BULLETIN K151 A
MODELS AFFECTED: All
SUBJECT: Torque Values for Rolled-Thread Cap Screws

BULLETIN K152
MODELS AFFECTED: All
SUBJECT: Loose Coils and Coil Retainers

BULLETIN K153A
MODELS AFFECTED: All
SUBJECT: Revision of Torque Values

BULLETIN K154
MODELS AFFECTED: All
SUBJECT: Fractures of Crankshaft-Sprocket Ends

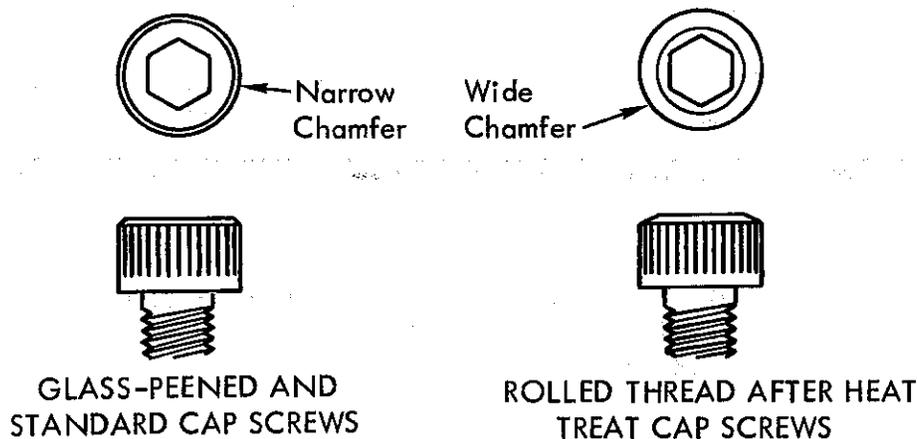
Rolled-thread connecting rod cap screws (P/N 60210A, 60211A and 47819A) are furnished on current production engines and are available for service. The process of thread rolling after heat treatment greatly increases fatigue resistance of the cap screws. The thread-rolled after heat treat screws can be told from the glass-peened or standard cap screws as shown in the illustration.

When installing the new screws, first oil the threads and then tighten the screws to a torque of 105-110 inch-pounds (1.22-1.28 mkg).

Because of the greater compression ratios and higher speeds at which the modern two-cycle engine operates, it is desirable to use new screws each time the connecting rod is reassembled rather than attempt to re-use the old screws. Once a screw has been torqued to the above values, a certain amount of stretch will occur. If the same screw is re-used, it will be stretched further yet. Naturally this additional stretch may prove to be detrimental to the future service life of the screw. The use of new screws each time the connecting rod is reassembled, postpones, if not prevents, breakage and subsequent damage to the engine.

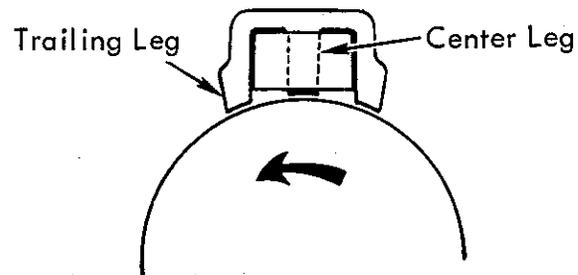
Most of such damage can be avoided by keeping the coil lamination mounting screws very tight. It will also be helpful to apply a sealant to the coil retainers, to assure a firmer grip on the lamination leg. To apply the sealant, the retainers must be removed from the coil.

Smear a small amount of RTV 732 Sealant on each of the four corners of the lamination center leg, covering about 1/2 inch of the open end of the leg. Allow the sealant to dry approximately one minute, then reassemble the coil, lamination, and retainers.

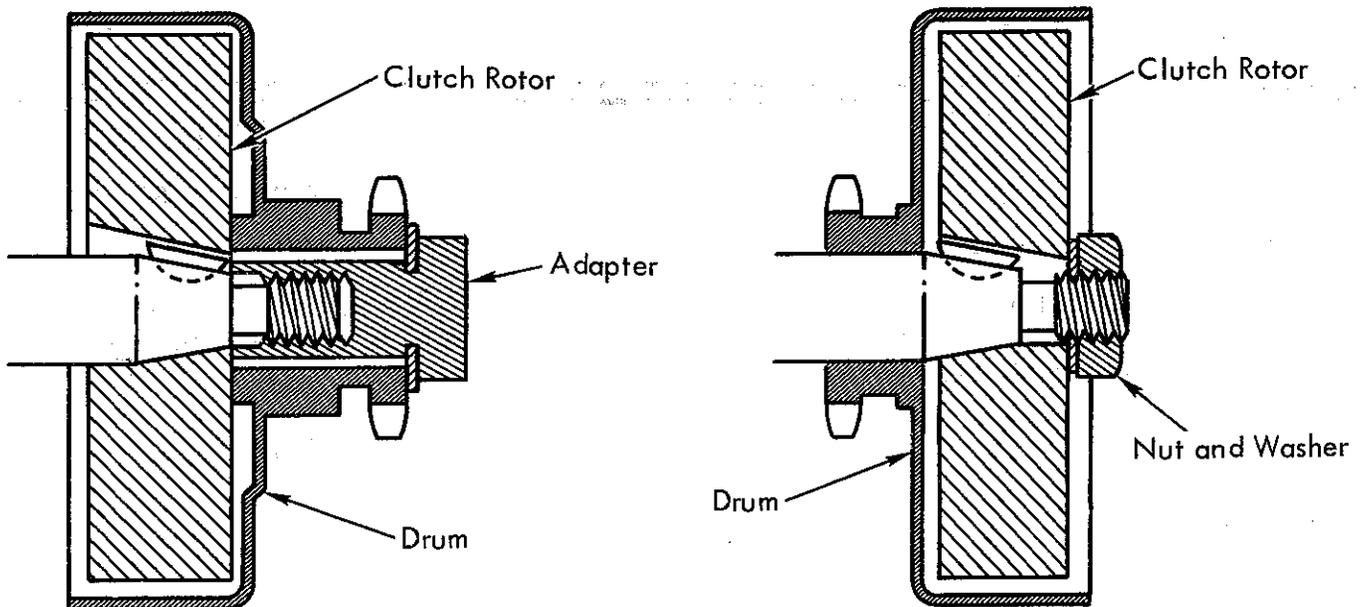
"Outboard-type" clutches (see illustration) should not be used with McCulloch kart engines. Recent investigations of reports which indicated breakage of the threaded portion of crankshafts, revealed that "outboard-type" clutches had been used.

"Outboard-type" clutches, due to their weight, put an excessive load onto the crankshaft.

We recommend that only McCulloch or McCulloch-type clutches be used and that the retaining nuts be torqued to our specification.

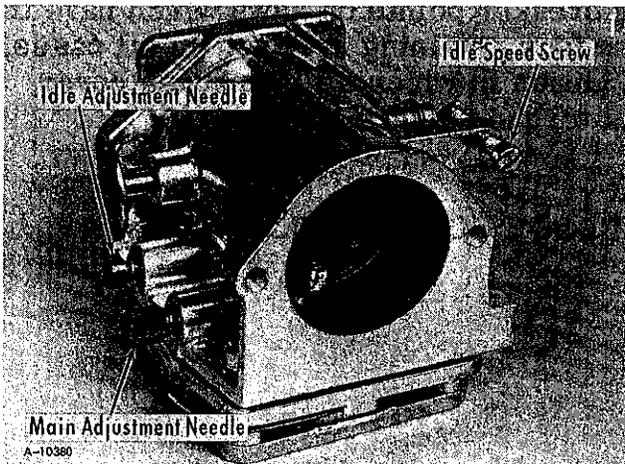
1. Close the main and idle fuel adjustment needles (turn clockwise) until they just seat (Figure 1).

3. Start the engine and warm it up to operating temperature.
4. Adjust the idle speed regulating screw until the engine runs smoothly at lowest speed with the throttle off (Figure 1).

IDLE CLUSTER COVER PLATE

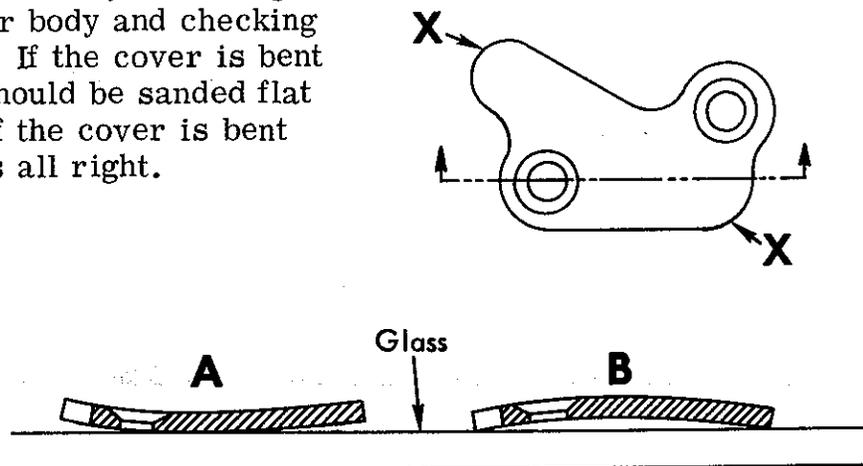
Another possible cause of incorrect carburetor adjustment is fuel leaking under the cover for the idle fuel cluster (identified as "cover - capillary" in the Illustrated Parts List) at high speed. If there is a leak, unmetered fuel flows, under pressure, from the two idle pick off holes in the barrel of the carburetor and again the main adjustment needle is used to compensate for a rich condition (Figure 2).

The cover may be checked by removing it from the carburetor body and checking it on a surface plate. If the cover is bent as shown at "A", it should be sanded flat on a surface plate. If the cover is bent as shown at "B", it is all right.
